NUMBER
PTR13058

LINE	QUANTITY	UOP	CAT. NO.	ITEM NUMBER	UNIT PRICE	AMOUNT
ADDENDUM NO. 2						
THIS ADDENDUM IS ISSUED TO MODIFY THE ORIGINAL SOLICITATION PER THE ATTACHED DOCUMENTATION.						
0001	1	EA	557-05	158" WHEELBASE BUSES (CUTAWAYS)		
***** THIS IS THE END OF RFQ PTR13058 ***** TOTAL:

Addendum Number: 2

TECHNICAL QUESTIONS/ APPROVED EQUALS ON PTR13058

Floorplan #1

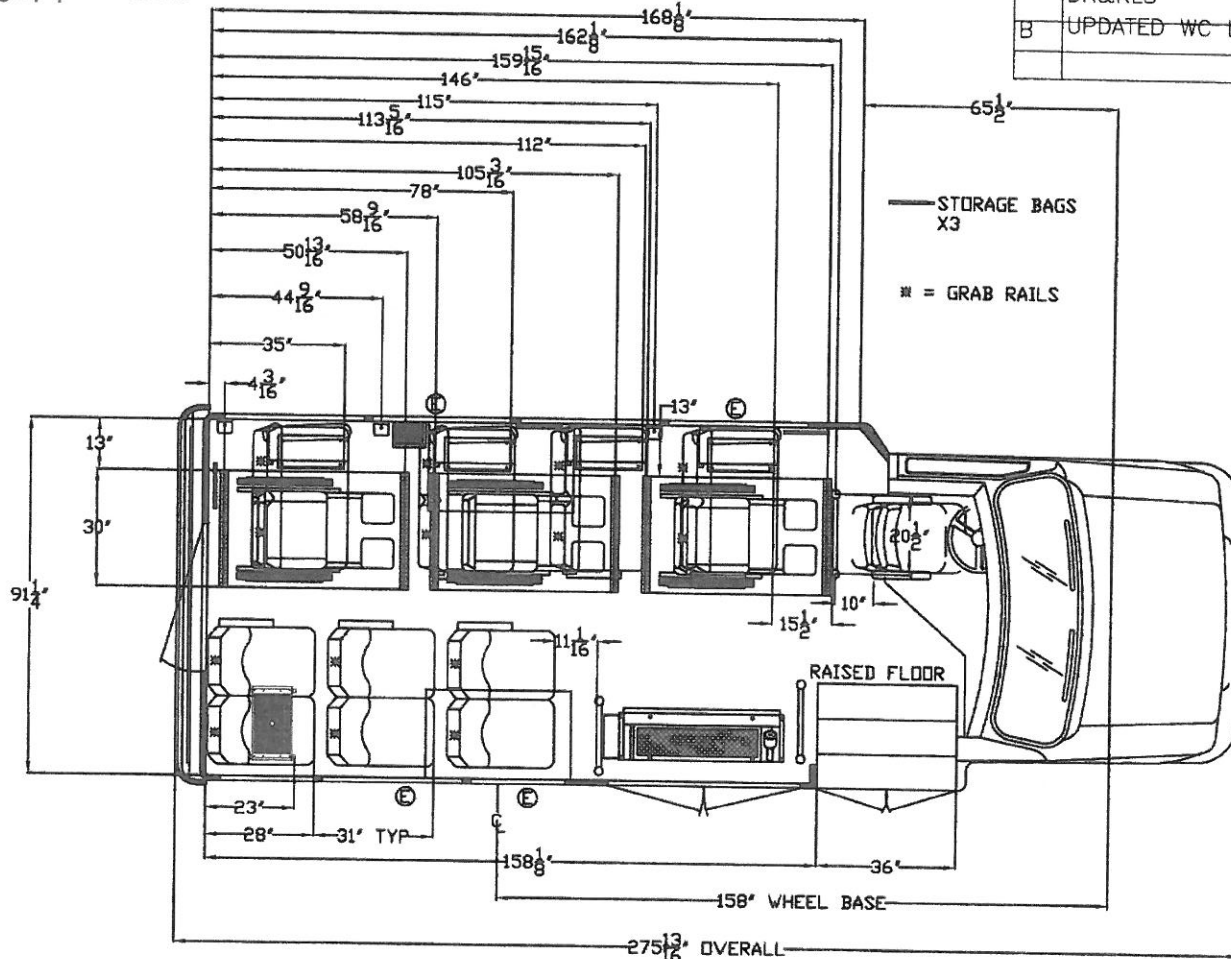
4.5.1 Class E calls for a front lift, extended body length and a third WC positions. How many fixed ambulatory seats and how many fixed fold away seats will be in this class vehicle? Will attached floorplan 1 or 2 be acceptable?

Page 97 and 98—The Seating Diagrams on page 97 and 98 do not seem to correspond to any of the requested classes. Please advise if these were added in error or which class each diagram corresponds to

The 4 ambulatory + 3 tie down positions (Floorplan 2) would preferred.

We were advised to include sample floorplans—the capacity should be as specified; these are merely for guidance
